6. Infrastructure and Transport

HUMMOCK HILL ISLAND DEVELOPMENT

Figure 6 -1 Preliminary Design of Colosseum Inlet Boating Facilities

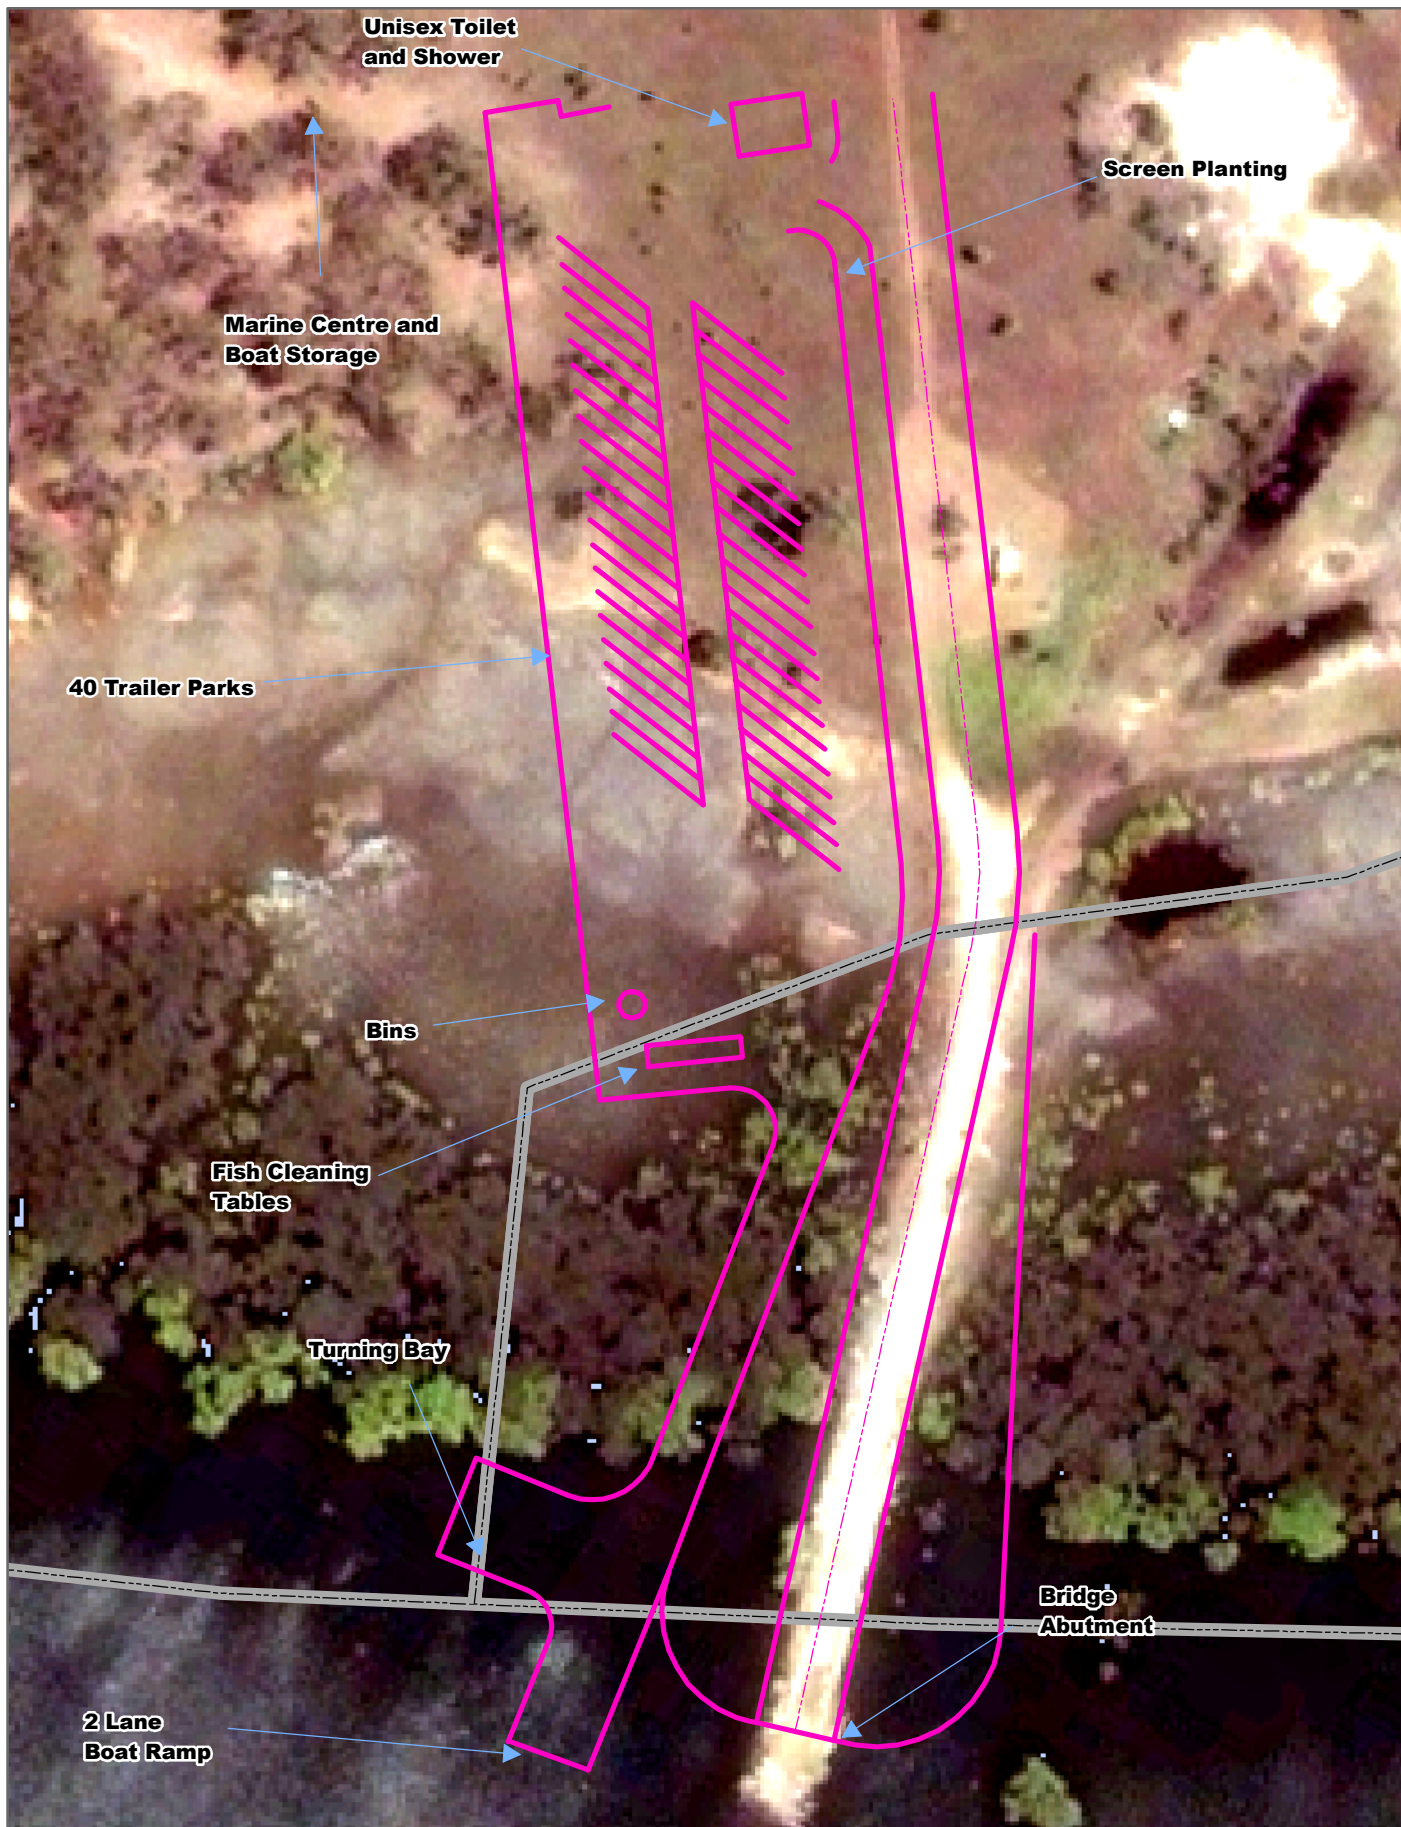
Several submissions requested further information about the provision of boat queuing facilities.

An estimated 20 - 30 boats will be in use on any given day (see Table 9.10 in the EIS). Based on daily usage rates the over-utilisation of boating facilities is expected to be minimal. Allowance will

be made for parking large towed vehicles, including the provision for drive through parking bays designed to accommodate a vehicle and trailer. These parking bays will be three metres wide and 15 m long. There will be 40 trailer parking bays at both the Boyne Creek and Colosseum Inlet boat ramps.

Both boat ramps on Hummock Hill Island will have two lane access, toilets, bins and fish cleaning facilities. Colosseum Inlet boat ramp will provide access to BBQ's and a picnic area, and Boyne Creek boat ramp will provide showers, a marine centre and boat storage facilities (**Figure 6-1** and **Figure 6-2**).
